FERN CREEK 20 PLAT

SUMMARY

<p>Owner Mark Kinchla</p> <p>Applicant Tom Kilgore</p> <p>Project Planner Michaëlle Petion, AICP</p> <p>Updated: April 1, 2016</p>	<p>Property Location: 1608 Park Lake St., 1605 & 1609 Woodward St., 741, 743, 745 N. Fern Creek Ave. (Southeast intersection of Park Lake At. & N. Fern Creek Ave.) (Parcel ID # 19-22-30-1512-03-060, -100, -110, -090, -081, -071) (±0.96 acres, District 4)</p> <p>Applicant's Request: Minor Subdivision for the replatting of six lots into 20 lots for a new townhome development.</p>	<p>Staff's Recommendation: Approval of the request, subject to the conditions in this report.</p>
--	--	--

BOUNDARY SURVEY

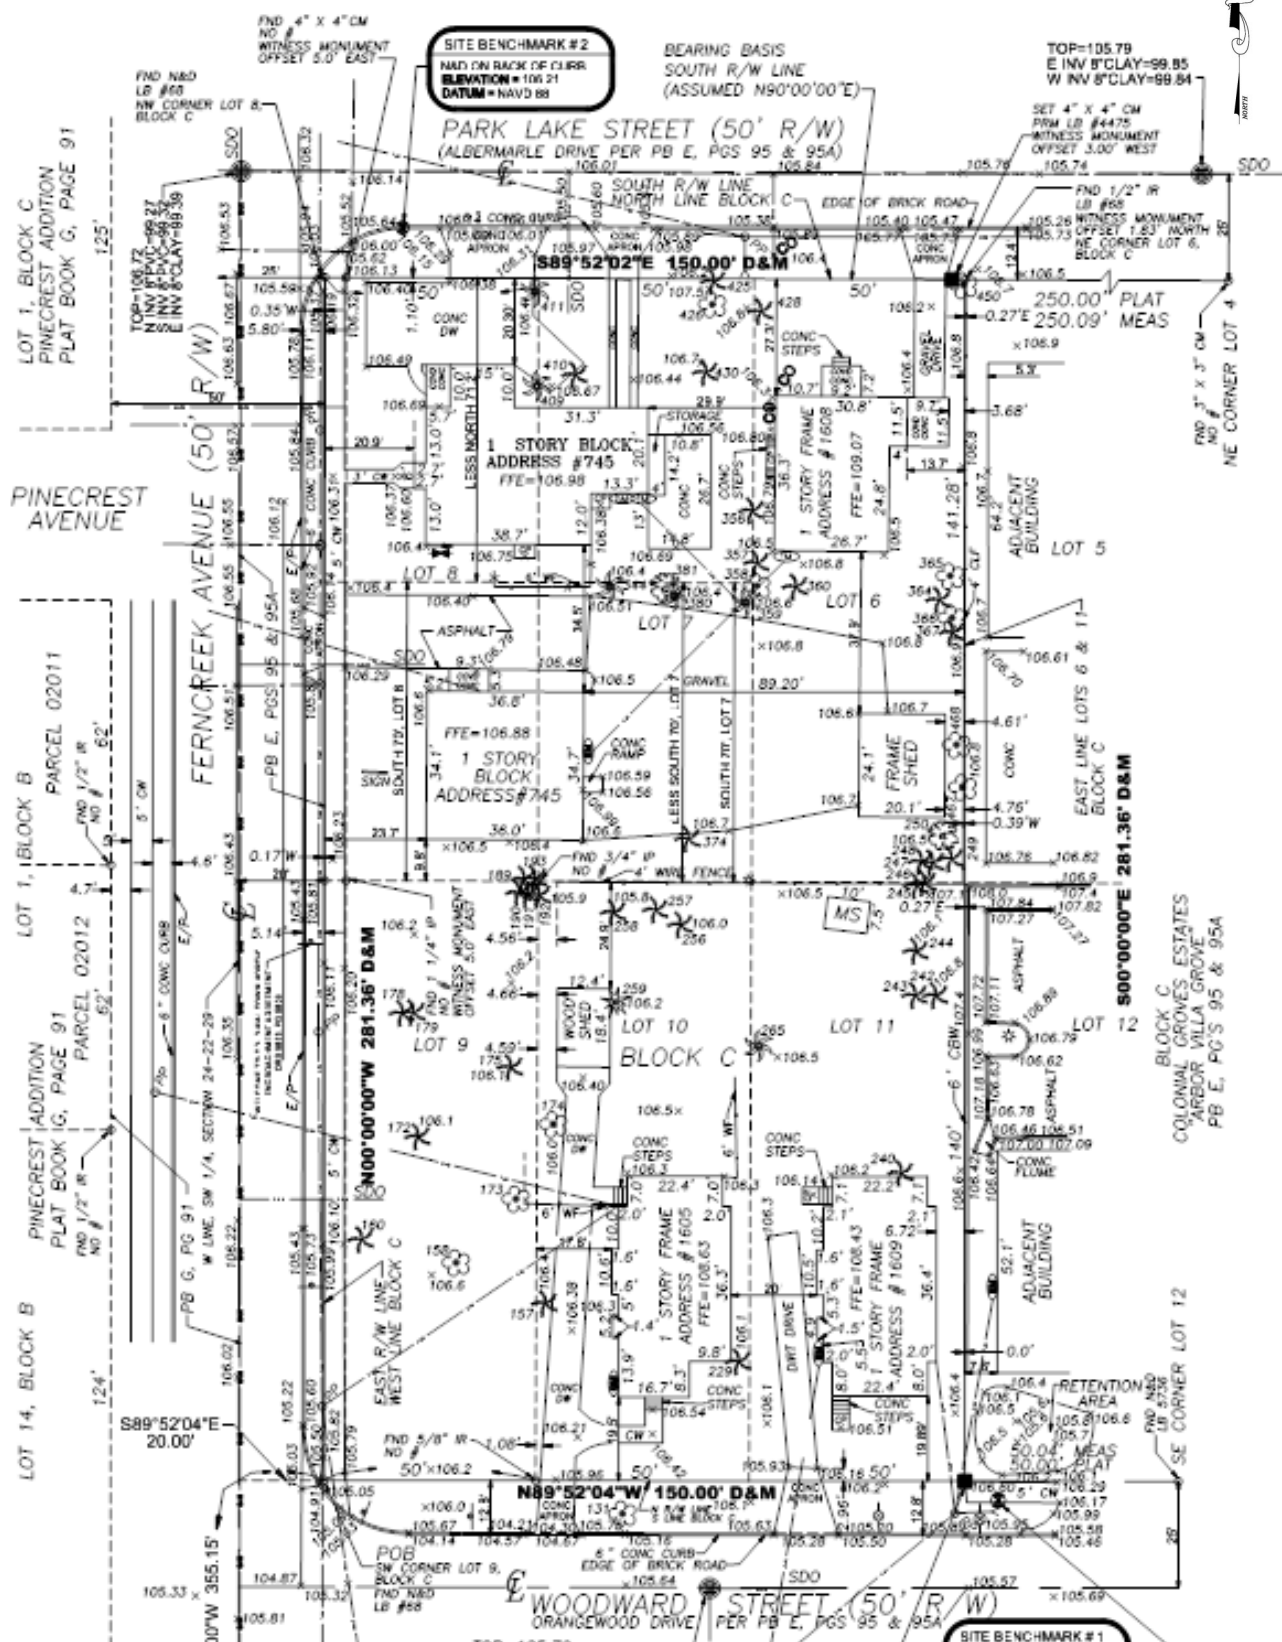
1. Need to show dedication along Ferncreek for on-street parking locations, and dedicate City Services/sidewalk easement for all locations that are sidewalks around all sides of the project. Please revise and resubmit plat prior to council action on the minor plat.

1. State on face of plat that access and utility easement is to be privately maintained.
2. State on face of plat private shared access aisles between units

10. Identify whom the AE and UE are to be maintained by.
11. Need the plat correct of all staff comments prior to recording. The Recording Fee shall be paid prior to recording. The Settlement
